PLUMBING AND MECHANICAL
INTERPRETATION MANUAL

CODE REF: Table 709.1 7 IRC Table 3004.1

SUBJECT: 2" Shower Drain Reduction

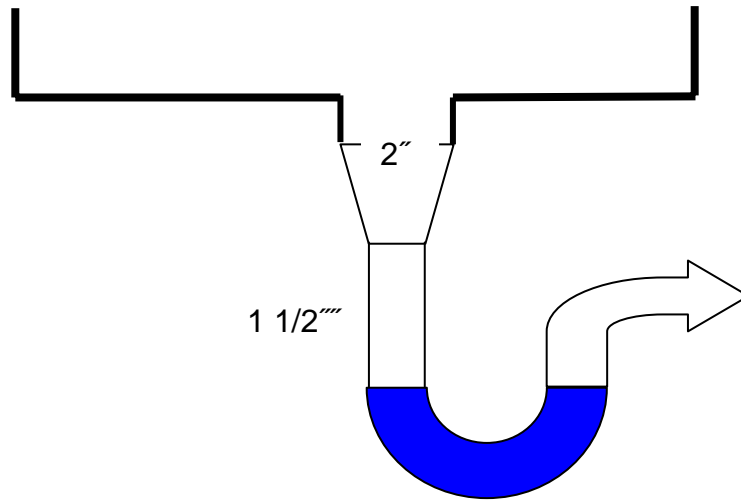
Question: Can a 2" shower drain be reduced to 1 ½" to connect to a minimum size 1 ½" p-trap (Table 709.1) with being considered a restriction (704.2)?

Answer: The transition from 2 inch to 1-1/2 inch occurs in a vertical section of pipe. At first glance, it would logically seem that Section 704.2 would also prohibit this arrangement. However, there is code change history and logic that allows this arrangement to be acceptable.

Therefore, where the transition from the 2 inch drain body to a vertical 1-1/2 inch pipe, a reducer is allowed because in most cases, there isn't any other way to make the connection. If a 'ledge' is created in reduction (such as where a reducing bushing is used), the reduction is no worse than the reduction that occurs within the drain body itself. Control turbulence is also not an issue as flow is already fairly turbulent from transition through the drain body.

Conclusion: The transition from 2" to 1 1/2" would not cause any problem as long as it is as close to the shower drain as possible to the shower pan fitting. A shoulder bushing would not be appropriate for this reduction but a bell reducer would provide a smooth transition to the reduced size.
